DESIGN/DEVELOPMENT REVIEW COMMISSION
DESIGN REVIEW DISTRICT
HISTORIC AGENDA
EVALUATION SHEET
Case #11

ADDRESS: NX2210 Wayne Street (Project 1)

REVIEW DISTRICT: Elmwood Park Architectural Conservation District

NATURE OF REQUEST: Request for a Certificate of Design Approval for
new construction

Front Elevation

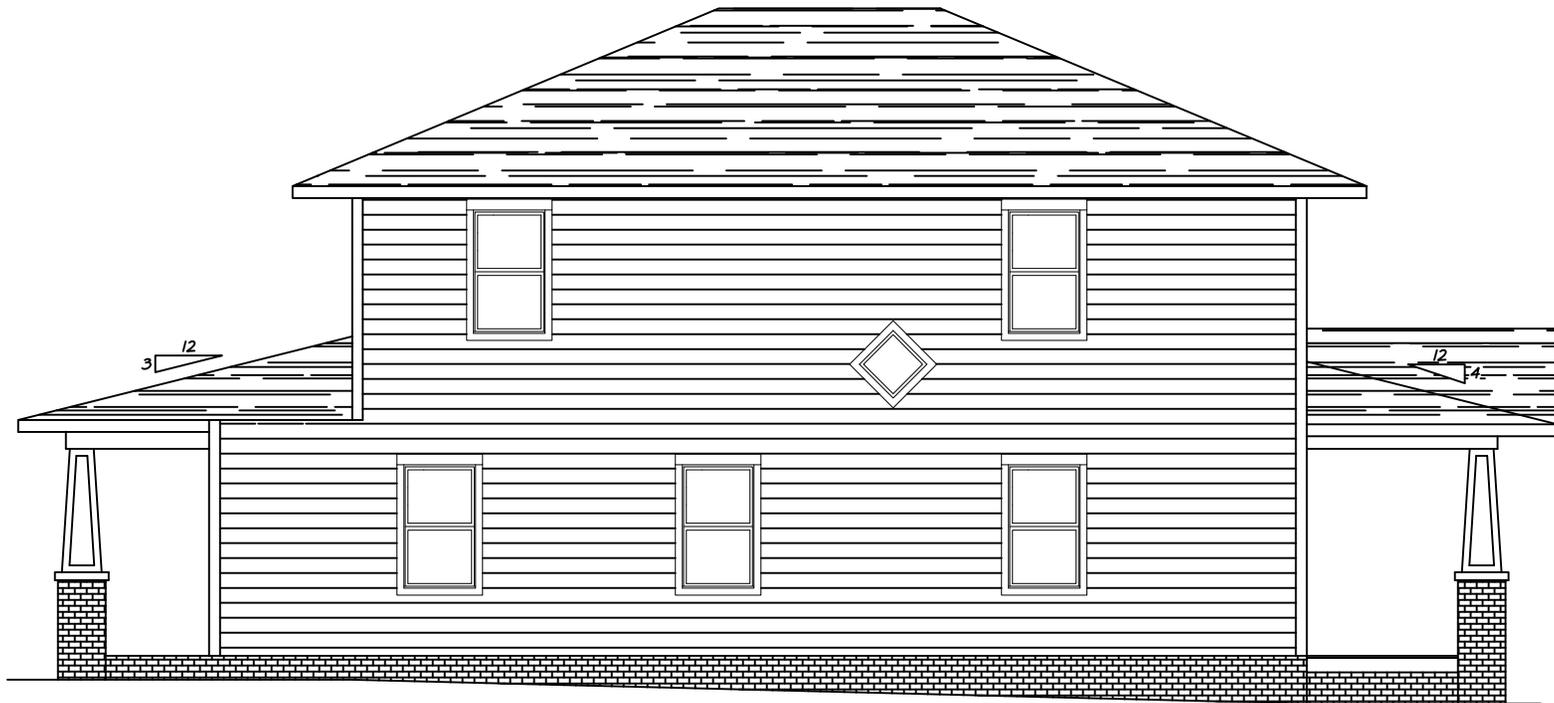
The front elevation shows a 5/12 pitch for the primary hip roof, but the rear elevation shows the same roof with a 6/12 pitch. Staff recommends the 6/12 pitch to be used as it is more visually compatible with other historic roof pitches found within the district. All roofing surfaces will feature 30-year architectural shingles.

Brackets: The front elevation shows eight brackets adjacent to the windows on the upper portion of the façade. These brackets are placed below the frieze board and do not appear to be supporting the eaves. Staff recommends removing the brackets as this is not typically an architectural feature seen on historic 2-story Foursquare houses in the Elmwood Park Architectural Conservation District.

- The primary roof pitch shall be increased to 6/12
- Cornice line brackets on façade shall be removed
- Windows shall be wood or aluminum-clad
- Windows on the first and second floors near the rear of the house on both sides shall be vertically aligned
- Setback of the house shall be flush with existing adjacent houses
- All details deferred to staff.
